**PLANNING COMMISSION
REGULAR MEETING**

Old Fire Station Commercial/Retail Use Site Plan Review & Off-street Parking
Variance

Address: 400 Ash Avenue North (State Trunk Highway 25)

Approval of a variance to reduce the number of off-street parking spaces required for a commercial/retail use in an existing building from the required thirty spaces to eight spaces and approval of a site plan for a new commercial use in an existing structure known as the old fire station.

Exhibit C – Exterior Elevations Dated February 28, 2024

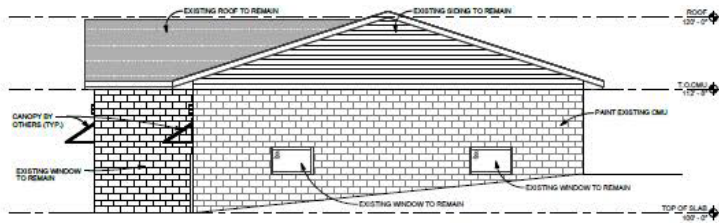
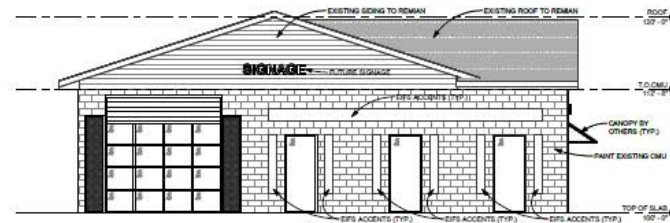
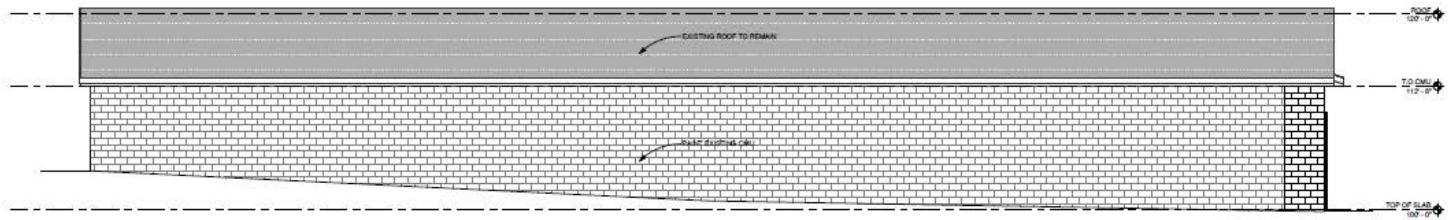
In the C-2 district visual relief shall be incorporate as follows. No front elevation or elevation facing a public right of way may exceed forty feet without the incorporation of visual relief. All new building elevations shall include a minimum of three of the following elements creating visual relief which the proposed building elevation does.

Architectural features which create a sculptural or three-dimensional quality such as marquees, balconies, grill work, sculpted keystones, caryatids, detailed cornices, brackets, niches, and awnings shall be incorporated into the design of buildings or structures. The proposed building will be using awnings over the doorways into each of the units.

The building plan submittal does meet the requirements of the C-2 district and building design standards in the zoning ordinance. An exterior building elevation is attached as an exhibit.

2. Building Design Standards. That the building design shall meet the requirements of section 152.101 Building Design Standards of the Municipal Code for the City of Mayer.

Exhibit F – Off-street Parking Layout Dated March 1, 2024

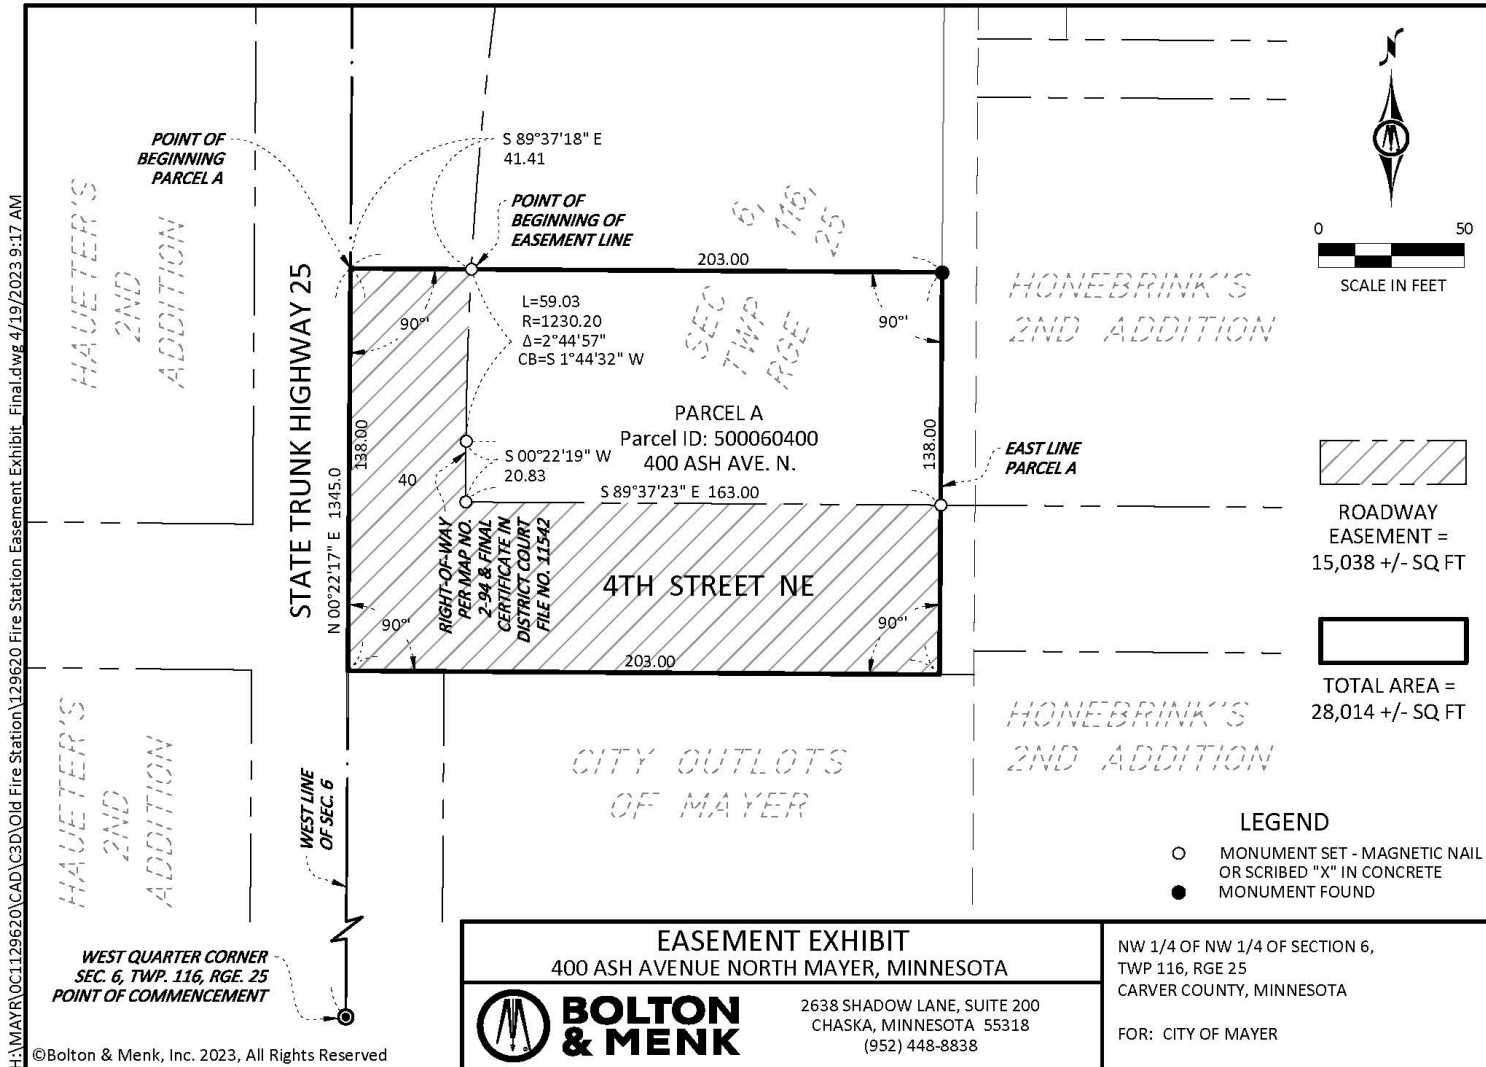
The applicant has submitted an off-street parking plan that shows a total of eight off-street parking space that are ten feet wide and twenty feet deep located completely on the property and another four off-street parking space, one being handicapped, that are partially in the 4th Street NE right of way and on the property. In addition to those spaces there are another ten spaces on the south side of 4th Street NE that are existing within the right of way which are also perpendicular in design.

The off-street parking requirement for retail is six spaces per 1,000 square feet. The building is 4,868 square feet in size meaning thirty off-street parking spaces would be required. Since only eight off-street parking spaces are completely located on the site, a variance would be required to reduce the number of off-street parking spaces, twenty-two spaces, from the required thirty spaces to eight spaces. The four off-street parking spaces that are partially located on the property and the ten spaces on the south side of 4th Street NE do not count towards the required off-street parking spaces since they are not completely located on the property, but can be considered when reviewing the variance request to reduce the required number of off-street parking spaces. It should be noted that a variance has been applied for and a public hearing has been scheduled for the same meeting as this site plan review.

All the off-street parking shown on the plan, including the eight off-street parking spaces located on the property are perpendicular to the street, meaning the automobile would enter the space and then have to back out of the space onto 4th Street to exit the site. This could potentially cause traffic issues and increase the possibility for accidents, but due to the existing nature of the site there is not many other options for off-street parking on this site. The ten spaces are already existing, but it should be noted these are public parking spaces and not specifically set aside for the proposed commercial property. There are other areas of this type of perpendicular parking in Mayer such as on 3rd Street NW west of Ash Avenue N.

Per the zoning ordinance, the City may modify minimum parking requirements in the C-2 District, if it is determined that the use is consistent with the purpose of the district and that street parking is sufficient to accommodate the use. This will also be considered when reviewing the variance. Parking and maneuvering areas are to be setback ten feet from all property lines or road easements and in this case that is not possible so that will be part of the consideration in the C-2 district.

1. Off-street Parking Variance. A variance shall be approved reducing the required number of off-street parking spaces from the required thirty off-street parking spaces, twenty-two spaces for a total of eight off-street parking spaces.
